Subject: Response to DEQ Comments on *Initial Stormwater Conveyance Mapping Results* from November 16, 2021

Project: Blue Heron Mill PPA
9-61M-135580.05

**Subject: Initial Stormwater Conveyance System Mapping Results – Revision 1
Former Blue Heron Property
419/427 Main Street
Oregon City, Oregon**

CONFEDERATED TRIBES OF THE GRAND RONDE		FORMER BLUE HERON PAPER MILL 419 MAIN STREET, OREGON CITY, OREGON	DATE DECEMBER 2021
			SCALE 1" = 50'
Wood Environment & Infrastructure Solutions, Inc. 15862 SW 72nd Ave., Suite 150 Portland, OR 97224		BASIN E AND F	PROJECT NO. 961M13558.04
			FIGURE 3D

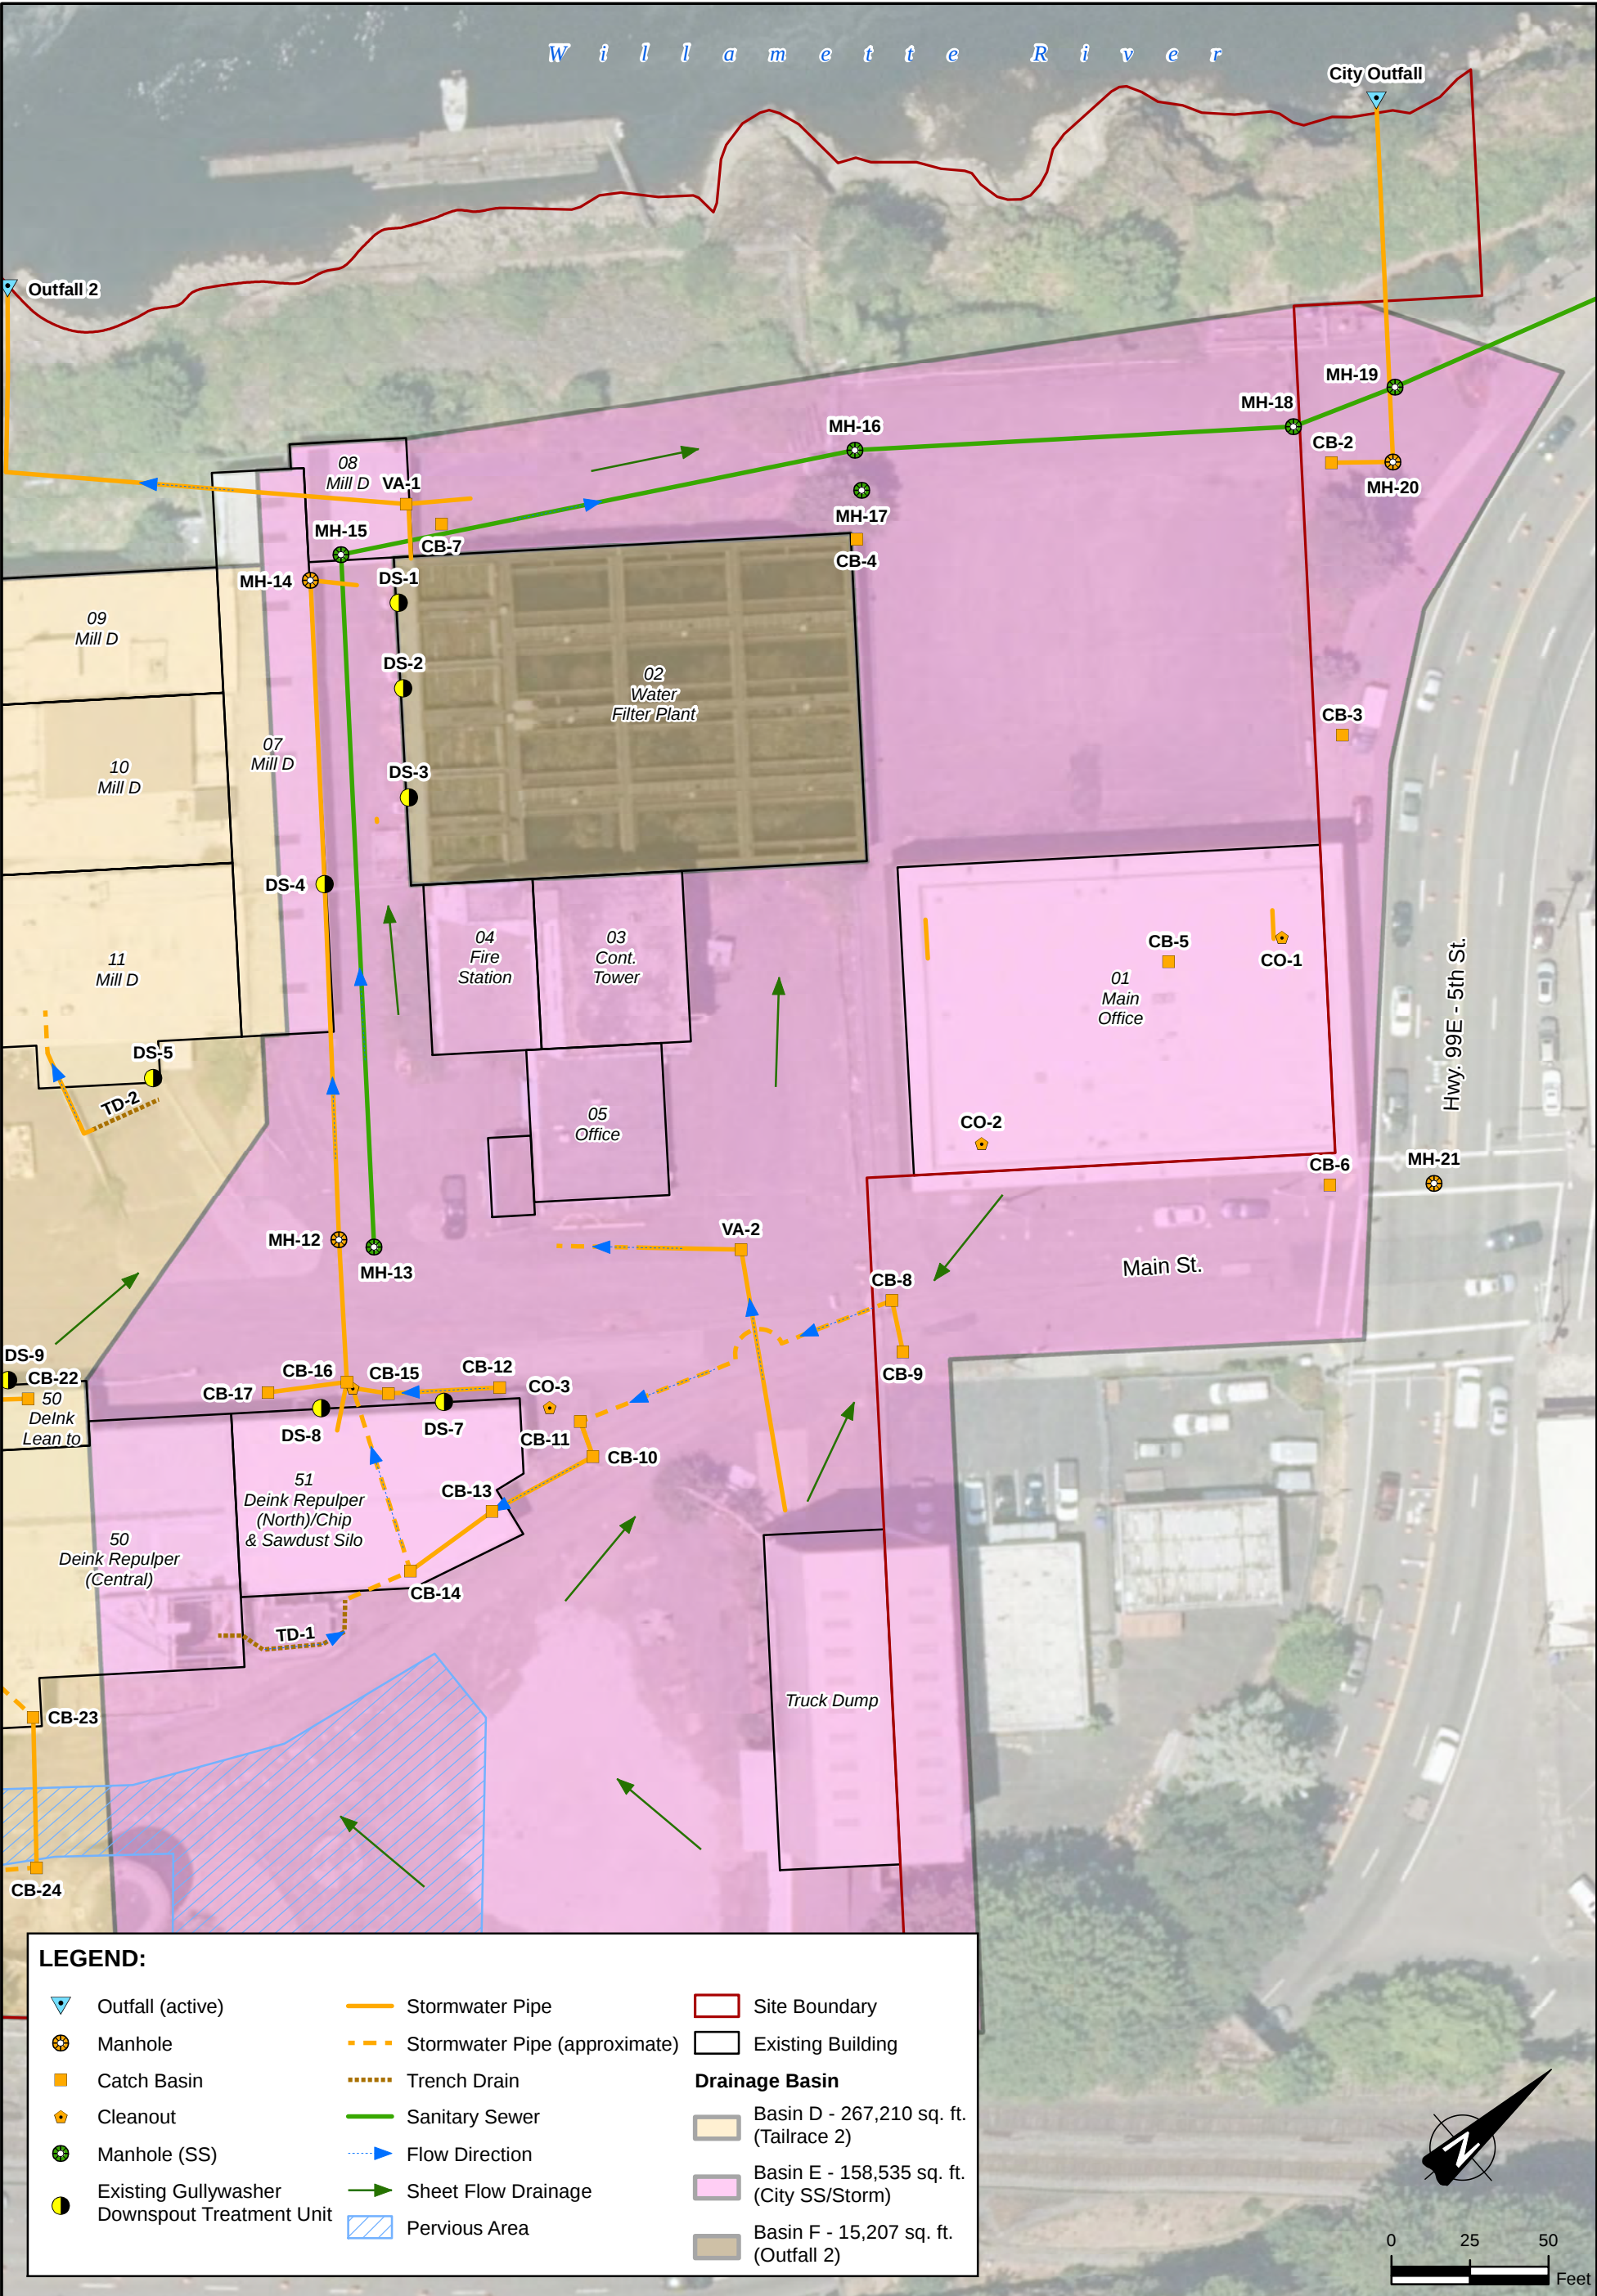
Please provide blown-up figures for each drainage basin to improve readability.

Large scale (blown-up) figures of each drainage basin are provided in Figures 3A-D.
